Technical Service Bulletin: TSB140017	Released Date: 16-Nov-2017
Breather Filter and Crankcase Tube Freezing Issue in Below Freezing Temperatures

Breather Filter and Crankcase Tube Freezing Issue in Below Freezing Temperatures

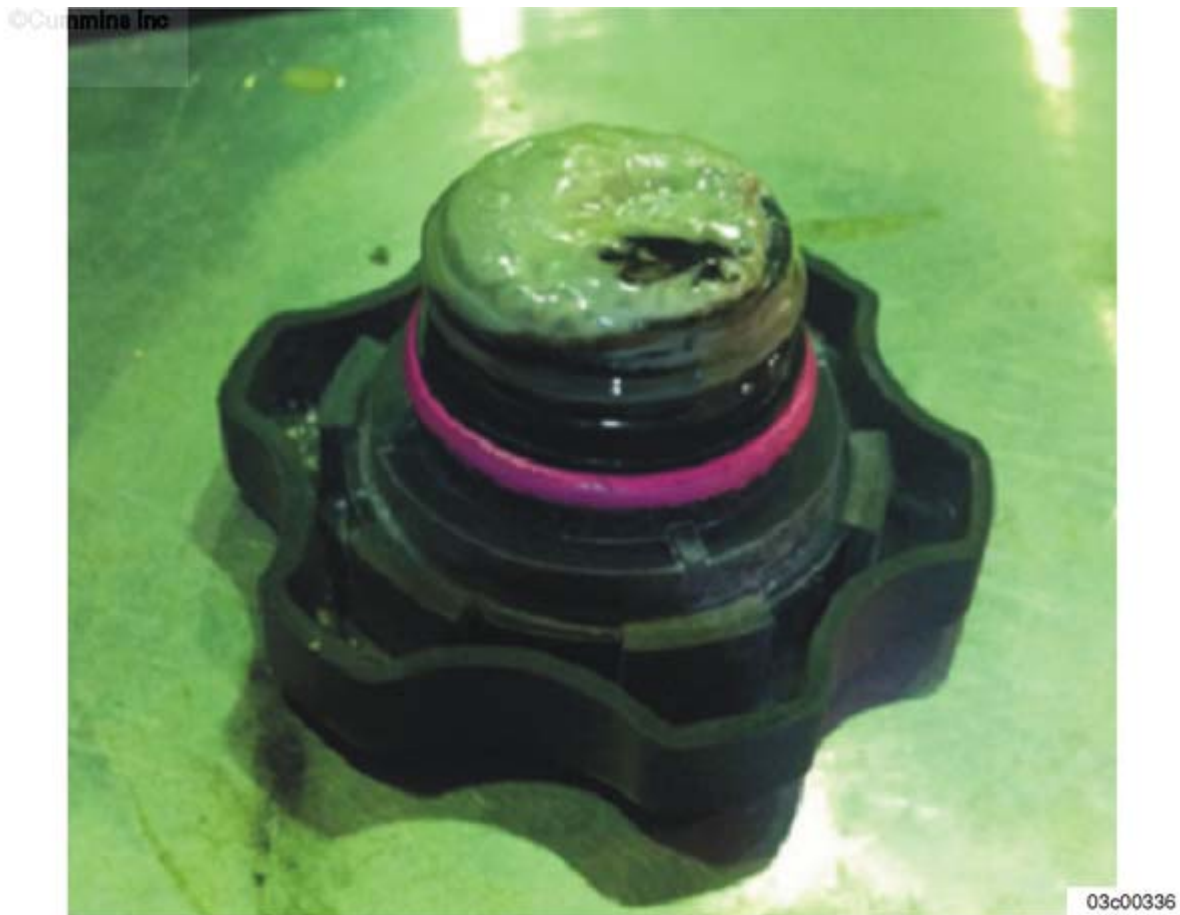
The crankcase breather filter and crankcase tube freezing could cause crankcase pressure to build, resulting in:

- Lubricating oil leaks at the turbocharger seal, valve cover gasket, and rocker housing gasket or front or rear crankshaft seals.
- Logging high crankcase pressure Fault Codes 555 and 556.

If these symptoms and fault codes are observed along with below freezing temperatures, check the breather filter and crankcase tube for freezing. Photographs are shown below for reference. Condensation might be observed on the breather element.

If the breather filter and/or crankcase tube is found to be plugged by icing, install the cold weather upfit kit, Part Number 5314954. Reference Service Bulletin 4908173 for detailed installation instructions. This kit contains two heaters that will keep the filter and tube from freezing in below freezing temperatures. This upfit kit is **not** covered by warranty.

Also, cut the crankcase breather tube at a 45 degree angle as shown in the illustration below. For On Highway engines, make sure that the open side of the tube either faces rearward from the vehicle's forward direction or toward the engine and for Off Highway engines, the open side **must** be facing toward the engine.
